**Staff Report
(with attachments)**

Development Review Staff Report

College and Trilby Multifamily #PDP220009

Summary of Request

1. Modification of a Standard for Building Variation -- 3.5.2(C)

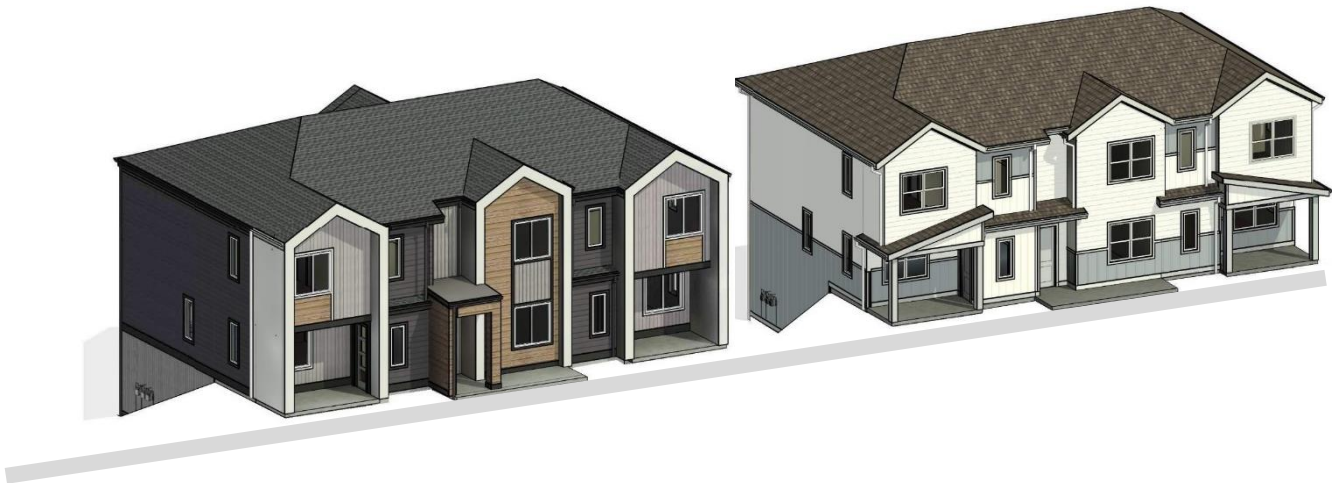
This standard for single-family attached dwellings (townhomes) requires variation among repeated buildings that have more than two units. At least 3 distinctly different building designs are required for the 3- and 4-unit buildings in this plan. This includes a requirement that the different designs must “vary significantly in footprint size and shape”; and no similar buildings may be placed next to each other.

This modification request is needed because 3- and 4-unit buildings with the same footprints are placed next to each other in numerous instances throughout the plan.

Staff finds that the modification of this standard would not be detrimental to the public good and that the request satisfies criteria (1) and (4) in subsection 2.8.2(H) – “equal or better” and “nominal and inconsequential when considered from the perspective of the whole plan.”

- The buildings placed next to each other are completely different in their exterior design as viewed on the ground, to a degree that accomplishes the purpose of the standard to avoid monotonous repetition of large apartment or townhome buildings and rather to provide visual interest, particularly at pedestrian scale.

When the overall missing middle scale is combined with the variation in placement that does exist throughout the plan, staff finds that it is most apparent when looking closely in a plan view drawing. On the ground, which is what matters, the instances of 3-plexes or 4-plexes next to each other have a negligible effect and would not be improved by, for example, putting buildings together to make 5-, 6-, or 7-unit buildings just to meet the standard.

Criteria (4), “nominal and inconsequential from the perspective of the whole plan.” From the perspective of the entire development plan, the instances of 3- and 4-unit buildings next to each other are nominal and inconsequential for the reasons stated above and do not affect the purposes of the Land Use Code.

2. Modification of a Standard for Street-Facing Facades – 3.5.2(D)(2)

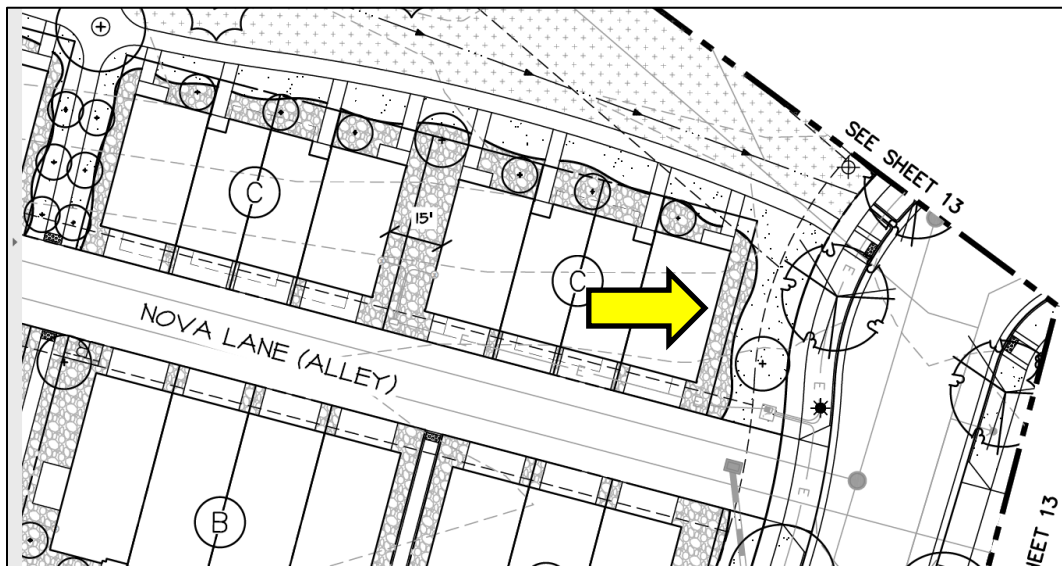
This is one such occurrence out of 85 buildings. The interior of the building is a garage partly below grade, with the grade in the outside yard sloping down along the building wall such that a doorway would be non-functional. The visual impact is mitigated by being located on a curve, and by two trees in the foreground closer to the sidewalk.

Staff finds that the granting of the modification would not be detrimental to the public good and that the plan satisfies criteria in subparagraph (4), "nominal and inconsequential" under Section 2.8.2(H) governing modification requests.

This one occurrence out of 85 buildings has virtually no effect on the look and feel of this 38-acre plan when considered from the perspective of the entire plan.

Criterion (4), "nominal and inconsequential". From the perspective of the entire development plan, the one end of one building facing Rover Drive without a doorway is nominal and inconsequential for reasons stated above and does not affect the purposes of the Land Use Code.
